APPLICATION NO.	FILING DATE	FIRST NAMED INVENTOR	ATTORNEY DOCKET NO.	CONFIRMATION NO.
09/923,611	08/07/2001	Frank Cornelis Penning	NL000452	1413

Office Action Summary

Final Rejection

1b. Bond slider wafer with via holes to head element wafer at about 185°C.

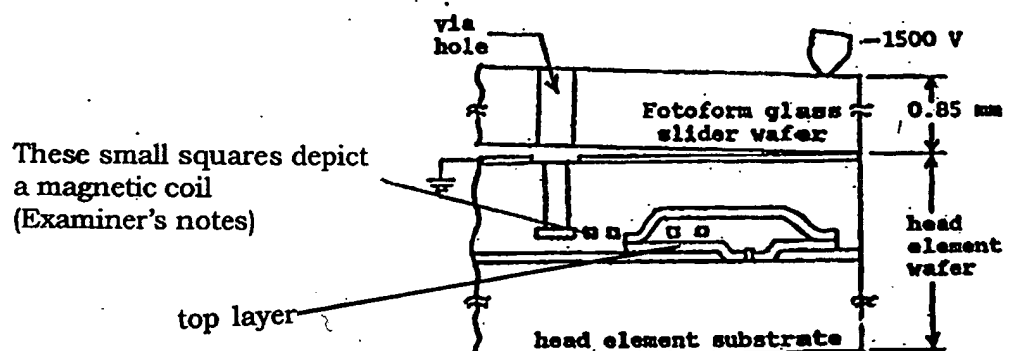
With regard to claims 1, 5, and 13, Chapman shows a method of manufacturing a magnetic head having a head face/a slider and having an air bearing surface (ABL in Fig. 1a) including small squares which extending parallel to the head face, in which method small squares formed on a top layer at a first side of a first substrate (head element substrate in Figs. 1a-1d), whereafter the first substrate provided with the small squares is adhered (Process Approach Section, lines 10-13) with its first side to a side of a second substrate (Footform glass slider wafer in Figs. 1a-1d), whereafter material of the first substrate (head element substrate) is removed from a second side of the first substrate to expose at least portion of the top layer (Fig. 1C and Process section, lines 13-15), which second side is turned away from the first side, to form the head face/air bearing face surface (Figs. 1c and 1d, "Process Approach" section, lines 7-16).

Chapman shows small squares in Fig. 1a, which is commonly used in the art to depict a coil but does not specifically pointing out it is a coil.

Figure 7. Horizontal Head/Slider Device with Inductive Write & MR Read

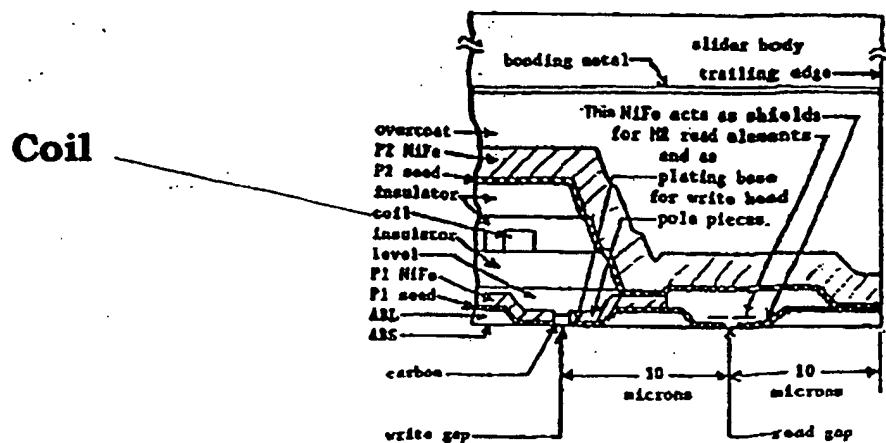
However, Chapman shows a head element in Fig. 1 with these small squares without indication on what the small squares are. However, Chapman shows in Fig. 1 a head element and shows detailed structure of the head element in Fig. 7, wherein it is explicitly indicated that the small square represents magnetic coil (Enlarged drawing is shown below). One of ordinary skill in the art would have been motivated to recognize that in Chapman's device, a magnetic coil extends parallel to the head face (Introduction, lines 1-4)/ near the air bearing surface.

- Applicant argues: "There is no magnetic coil formed on an edge of a substrate taught or suggested by Chapman. The only coil disclosed within Chapman is illustrated in Figure 7 and is not formed at an edge of any substrate."
- Examiner's answer: "magnetic coil formed on an edge of a substrate" is not cited in claims. It is noted that the features upon which applicant relies (i.e., the features recited above) are not recited in the rejected claim(s). Although the claims are interpreted in light of the specification, limitations from the

1b. Bond slider wafer with via holes to head element wafer at about 185°C.

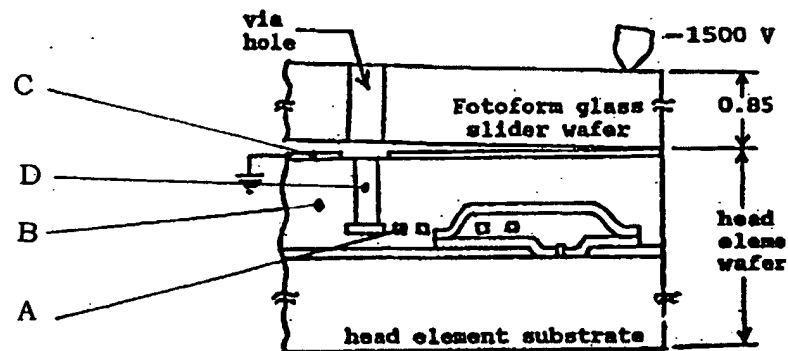
With regard to claim 3, Chapman further shows after a step involving the forming of a layer of a metal A (See the Figures with added numerals attached below) on the first substrate, at least one further step involving the forming of a layer of a non-conducting material B and the forming of a further layer of a metal C and the forming of interconnections D between two neighboring layers C and A of metal is performed to create the magnetic coil.
